Addendum 117: Regulation No. 118

Amendment 1

01 series of amendments - Date of entry into force: 9 December 2010

Uniform technical prescriptions concerning the burning behaviour and/or the capability to repel fuel or lubricant of materials used in the construction of certain categories of motor vehicles

Figure 4a

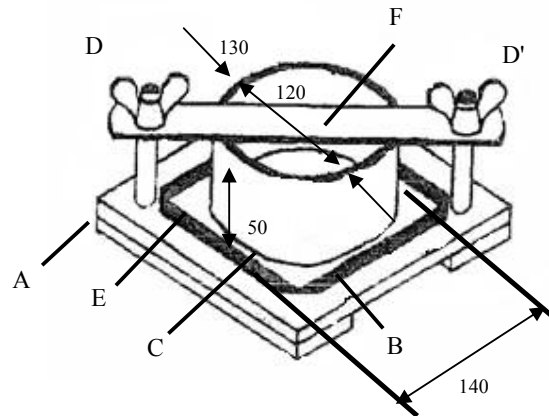
Insert a new Annex 9, to read:

- 2.4. Four samples shall undergo the test.
3. Apparatus (see figures 4a and 4b)
The apparatus shall consist of:
 - A a base plate, with a hardness of at least 70 Shore D.

- B an absorbant surface on the baseplate (e.g. paper);
 - C a metal cylinder (inner diameter of 120 mm, outer diameter of 130 mm, height of 50 mm), filled with the test liquid;

- D-D' two screws with wing nuts;
 - E the test sample;
 - F top plate
4. Procedure
 - 4.1 The test sample and the apparatus shall be conditioned for at least 24 hours at a temperature of $23 \pm 2^{\circ}\text{C}$ and a relative humidity of 50 ± 5 per cent and shall be maintained under these conditions until immediately prior to testing.
